XRAY XB2

SUSPENSION PIN TECH TIP

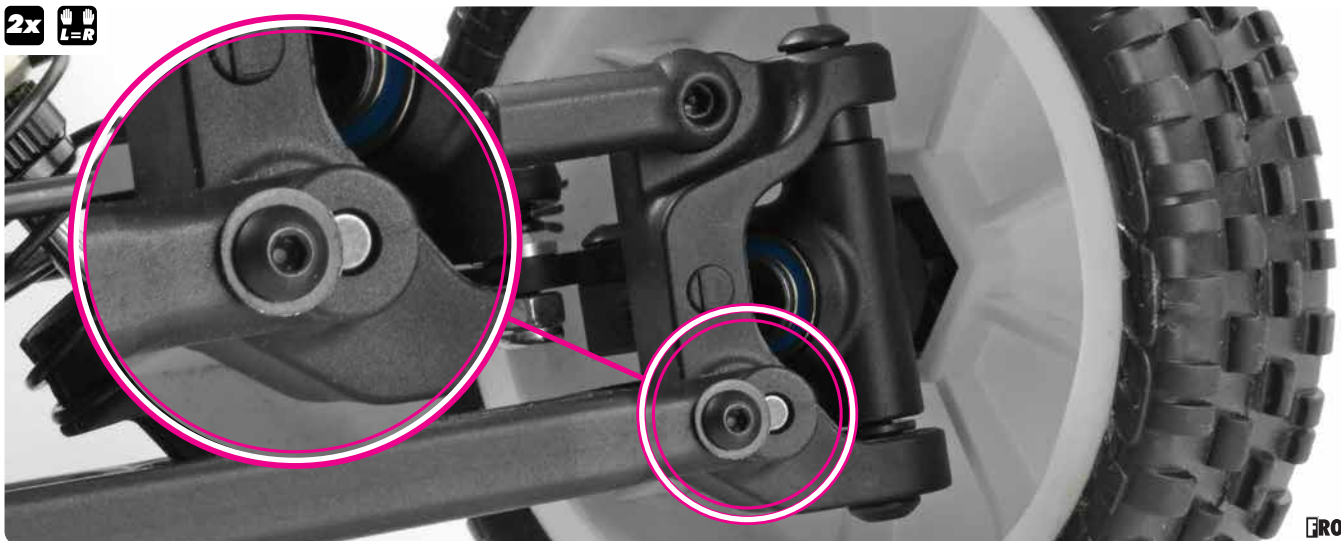
In some cases screw that secures the suspension pin may not hold the pin properly or sufficiently. In this case please use a 6mm wide shim in thickness 0.5mm under the screw as shown in the photo. The part number for the Washer is #961025.

#961025
Washer S 2.5 (10)
